November 2023
SF678 A
(Revised December 2023)

Subject: Freightliner Snow Plow Light Harness

Models Affected: Specific model years 2022-2024 Freightliner 108SD and 114SD vehicles, manufactured November 9, 2021, through July 24, 2023.

Daimler Truck North America LLC (DTNA), on behalf of its Freightliner Trucks division, is initiating Field Service Campaign SF678 to modify the vehicles mentioned above.

Fig. 3, Schematic - Snow Plow Light Wiring Modification

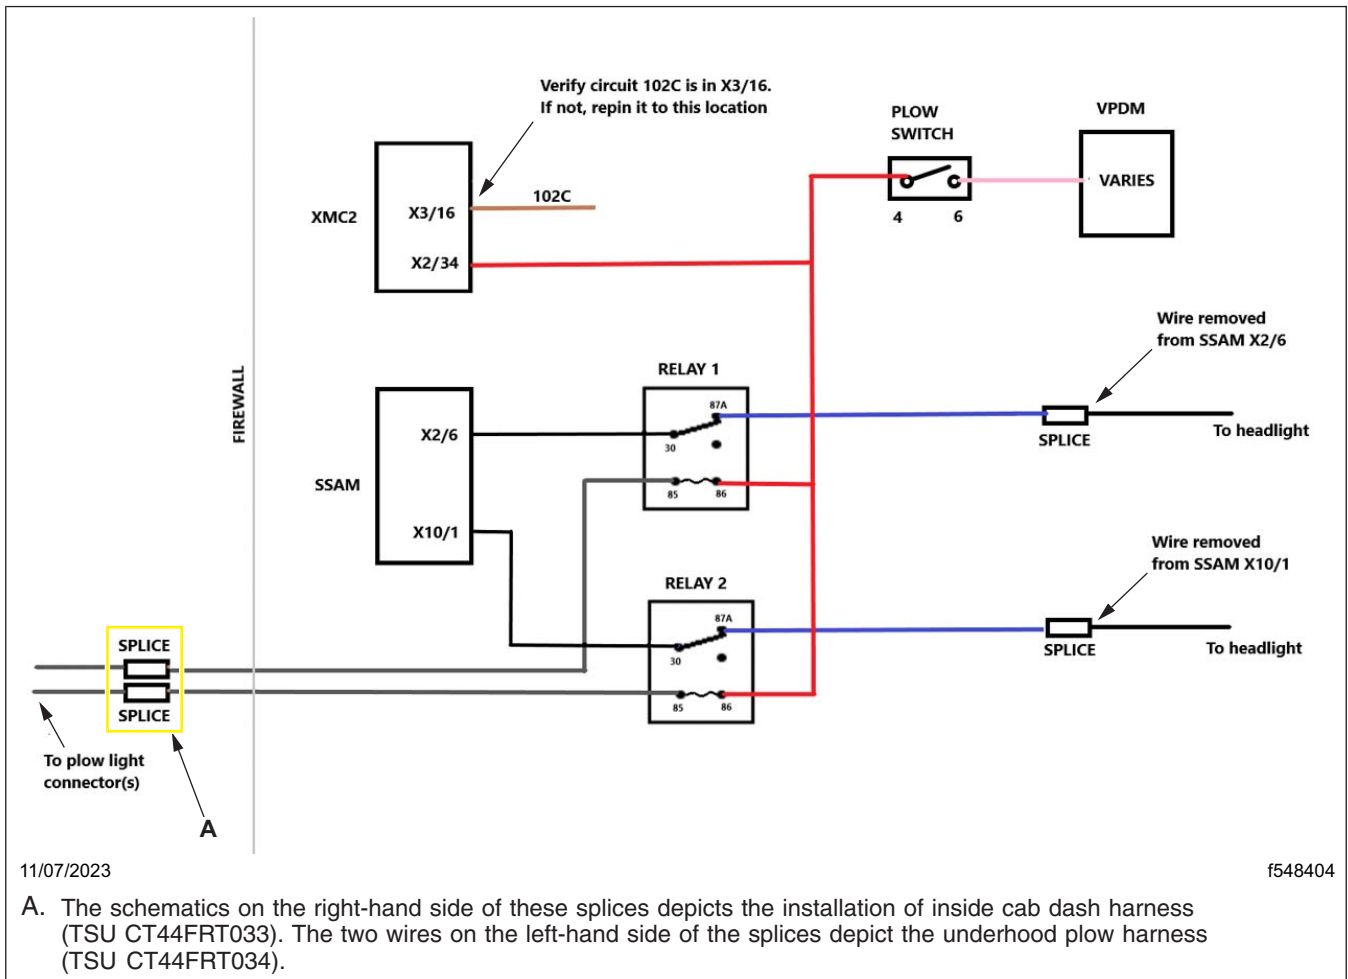
The instructions that follow involve installation of wiring harnesses in the dash and the engine compartment to modify the headlight function so that the headlights are interrupted when the plow lights are turned on. To aid in visualizing the repair, see the plow light wiring modification schematics shown in [Fig. 3](#), page 6.

A new snow plow light harness and switch will be installed, and the lighting parameters will be updated to deactivate headlamps when the snow plow lights are activated.

Fig. 69, Single Plow Light Interface Connector with the Plug Removed from the Empty Cavity (cavity G)

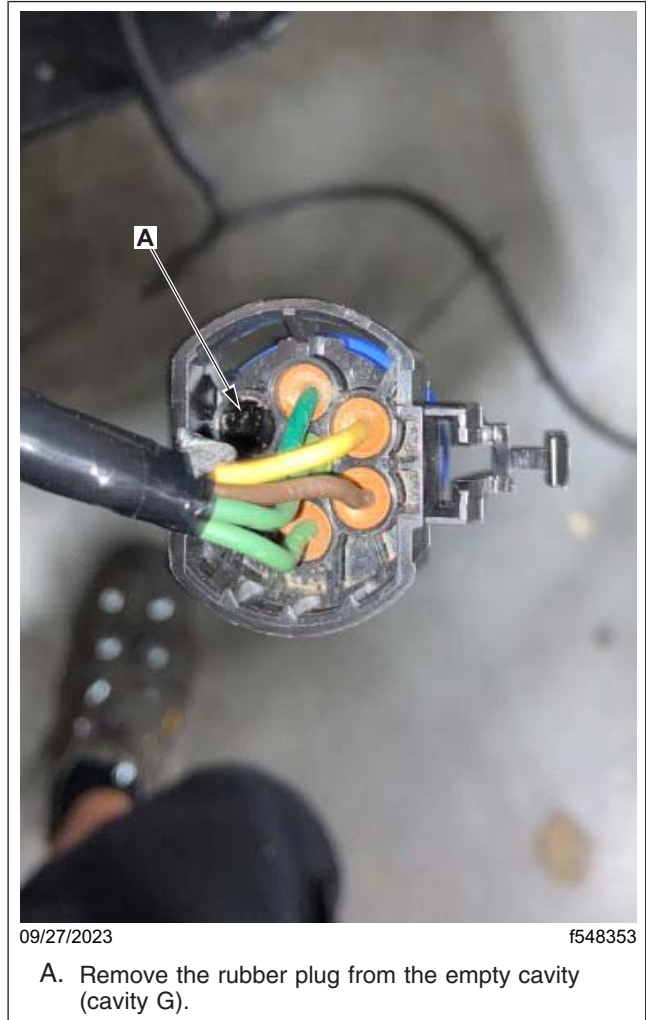
REVISION: Work instructions have been revised starting with the note prior to step 35. Two parts have been added to the parts table which apply to the single plow connector configuration. The original terminals and seals only applied to the dual plow light connector configuration. Dealers should order all terminals and seals listed, although some will not be used depending on the configuration.

35.2 Locate the empty cavity (cavity G) and remove the rubber plug. See [Fig. 69](#).
